Access Compliance Report

Public Rights-of-Way

Intersection ID: 10023378	Main Street: CHINA GROVE CHURCH RD	Cross Street: N/A	Location: NE
ADA ID: D176B4D8DF55	Ramp Type: PerpDiag	Initial Pass/Fail: Fail	Overall Compliance: No
Severity Score: 21.25			
Codes/Mitigation Info/Possible Solution		Field Measurements/Component Compliance

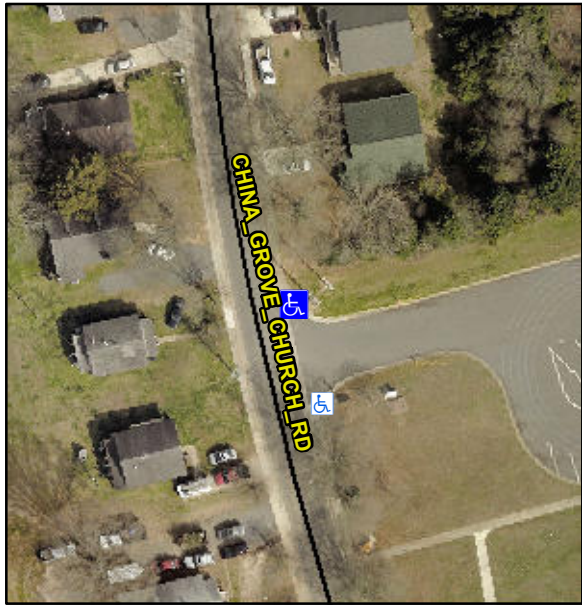
Compliance	Description	Data	Compliance	Description	Data
N/A	Ramp Length (in)	60.0	No	Ramp Slope (%)	9.6
No	Ramp Width (in)	47.0	Yes	Ramp XSlope (%)	1.6
N/A	Flare Type LT	N/A	N/A	Flare Type RT	N/A
N/A	Flare Slope LT (%)	N/A	N/A	Flare Slope RT (%)	N/A
N/A	Flare Traversable LT?	N/A	N/A	Flare Traversable RT?	N/A
N/A	Landing Length (in)	N/A	N/A	DWS Provided?	N/A
N/A	Landing Width (in)	N/A	N/A	DWS Contrast?	N/A
N/A	Landing Slope (%)	N/A	N/A	DWS Length (in)	N/A
N/A	Landing X Slope (%)	N/A	N/A	DWS Full Width?	N/A
N/A	Landing Curb? (Y/N)	N/A	N/A	DWS Offset (in)	N/A
N/A	Shared Landing?	N/A			
N/A	Gutter Ponding?	N/A	N/A	Gutter Slope (%)	N/A
N/A	Gutter Lip Ht (in)	N/A	N/A	Gutter X Slope (%)	N/A
N/A	Painted X Walk1?	No	N/A	Painted X Walk2?	No
	X Walk 1 Direction	To W		X Walk 2 Direction	To S
N/A	X Walk 1 Width (in)	N/A	N/A	X Walk 2 Width (in)	N/A
	X Walk 1 Slope (%)	4.0		X Walk 2 Slope (%)	2.0
	X Walk 1 X Slope (%)	0.7		X Walk 2 X Slope (%)	1.0

N/A	Ramp inside XWalk1?	N/A	N/A	Ramp inside XWalk2?	N/A
	Road Slope (%)	0.5	N/A	Clear Space?	N/A
	Road X Slope (%)	2.1	N/A	Clear Space to XWalk (in)	N/A
N/A	Any Obstructions?	N/A	N/A	Storm Grate/Utility Hazard?	N/A
	Obstruction Type			Storm Grate/Utility Type	
		N/A			N/A
			Yes	Surface Condition? (G/P)	Good

Possible Solutions:		Remove & Replace Curb Ramp With Two New Directional Ramps or Equivalent.	
	Surveyor Notes:		N/A	
	PROW/ADA:		Not Found, R304.5.1, R304.2.2	
	Street 1 Name		CHINA GROVE CHURCH RD	
	Stop Condition-Street 2		None	
	Street 2 Name		ENTRANCE	
	Stop Condition-Street 1		None	
	Total Cost:		\$ 3200.00
